Proposed Diversion of Public footpath 163a (part) Within Ratcliffe on the Wreake

We Discussed this proposal at Ratcliffe on the Wreake Parish council meeting on 16th March 2023. We carried a motion to send this letter representing the views of those present at the meeting. During discussion we and the villagers present could not see any good need for this diversion.

Embankment “J” to “K” rutted from cattle movements. Photo of Causeway showing churned up surface 2022.

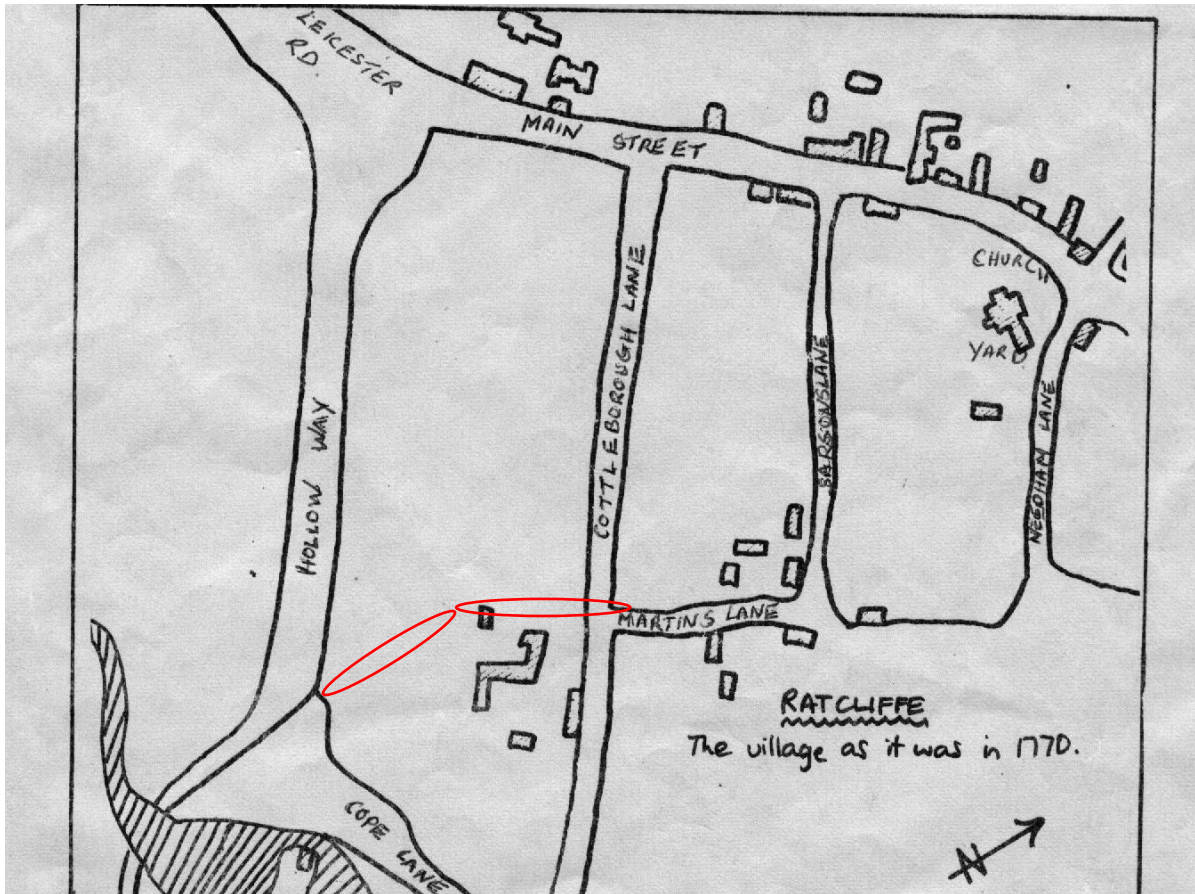
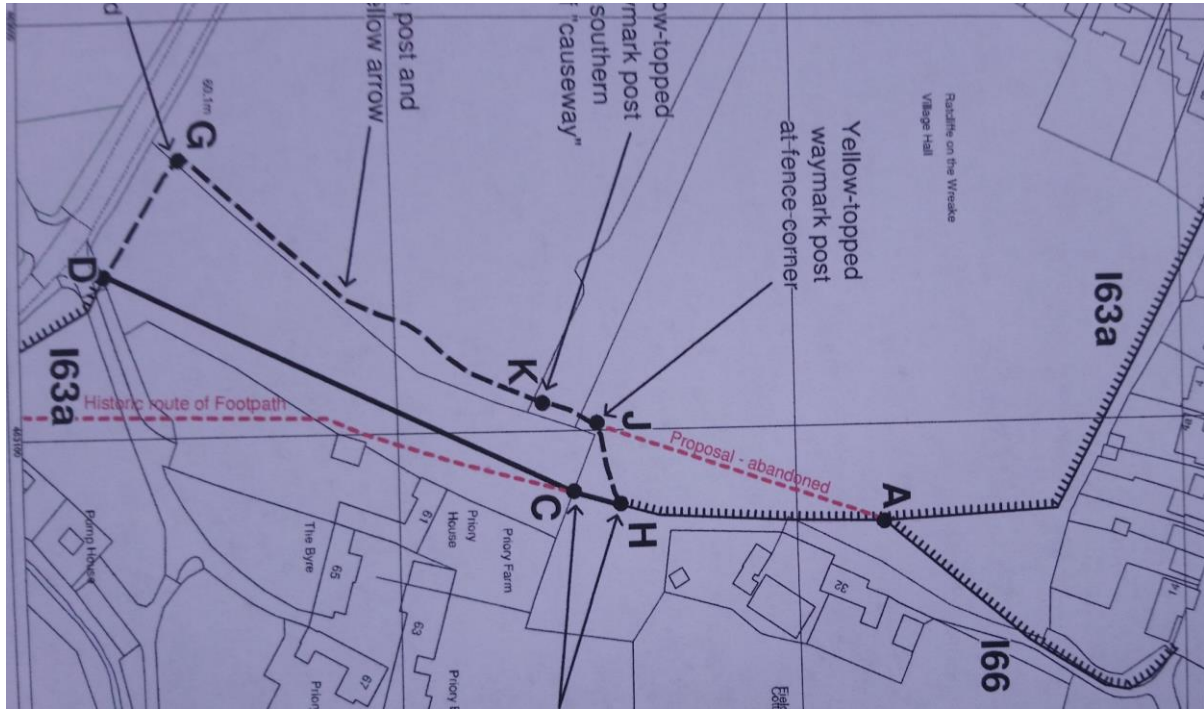
The new embankment has destroyed part of this feature and perhaps should be removed.

- H) The embankment between “J” and “K” is less than 3mts wide (4mts specified) and has steep sides into a ditch. See photo bellow.
- I) The recently built embankment between “J” and “K” is made of compacted soil and runs across a ditch “the dove cote” without any obvious drainage to prevent water building up, which could soften the soil and cause it to collapse the structure. Cattle graze these two fields normally without a barrier and they could also make the embankment treacherous.

1770 Map

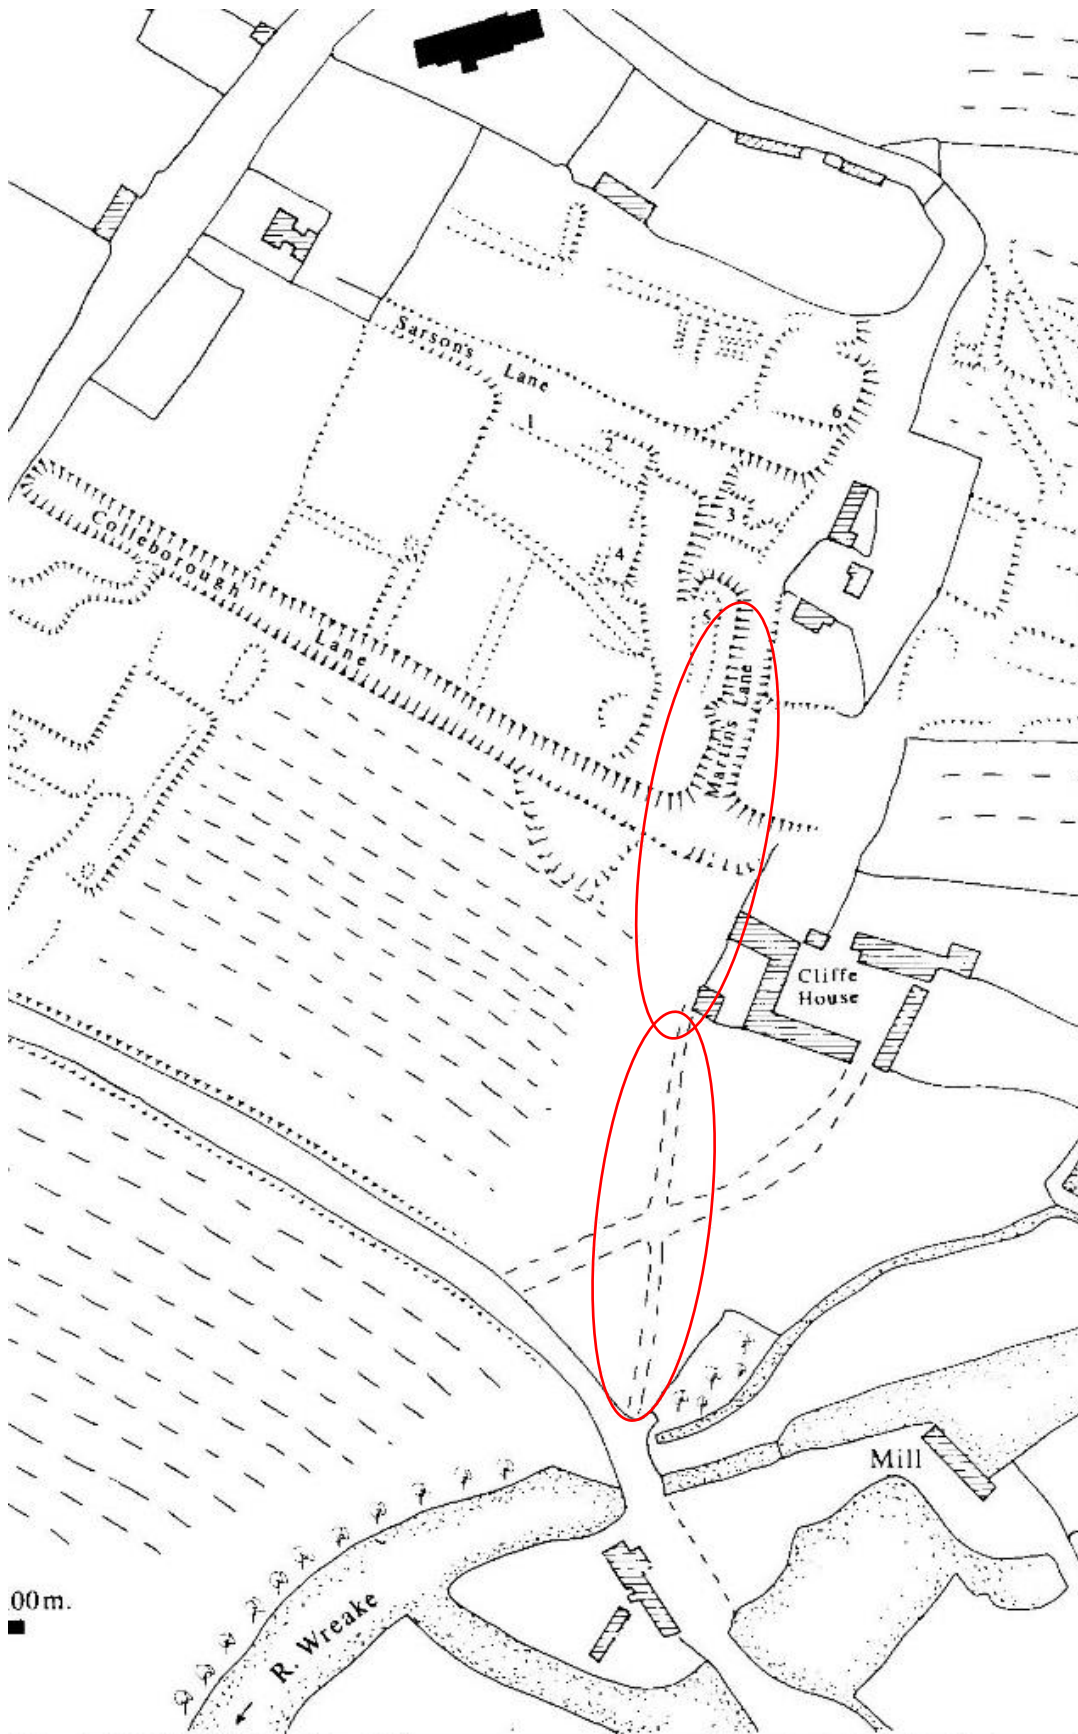
- G) The ditch between “J” and “K” locally known as the “dove cote”, was originally Cottleborough Lane as shown on 1770 map attached where it connects Main Street to Martins Lane, this is also part of the character of the village as detailed in Conservation report 2013. and is one of the Boundaries that it mentions.
